Re: Review of landscaping plans of North Penrith Stage 2A

The purpose of this letter is to summarise the outcome of a review of plans and documents. This review has been conducted with regards to the proposed public domain works and road/infrastructure plans for Stage 2A for consistency with the 2010 Flora and Fauna Assessment (Eco Logical Australia 2010). In this regard the following documents were reviewed for consistency with 2010 Flora and Fauna Assessment:

Figure 1. The Cumberland Plain Woodland remnants occur primarily in the areas marked as OS2 and C3 (included in Eco Logical Australia 2010 as Figure 10).

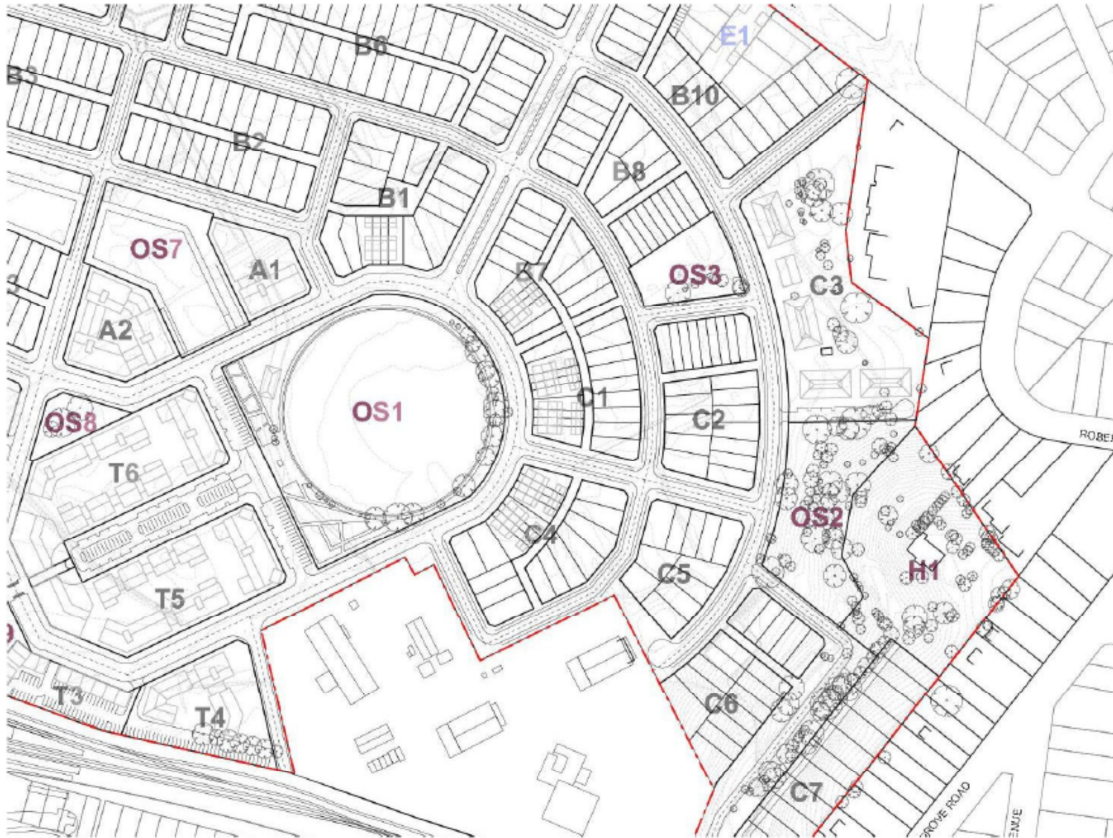
- Landscaping in the OS2 Park (see Figure 1 for location). These works were to include "...landscaping will remove trees in the middle of this patch to create sightlines, together with installation of retaining walls and a path with steps. Other paths will also be installed elsewhere in the park, resulting in the

- In the C3 area (see Figure 1 for location) some Cumberland Plain Woodland in the west and south of this area was to be removed as a result of the proposal, and some vegetation was to be protected via a section 88b instrument (Figure 2).
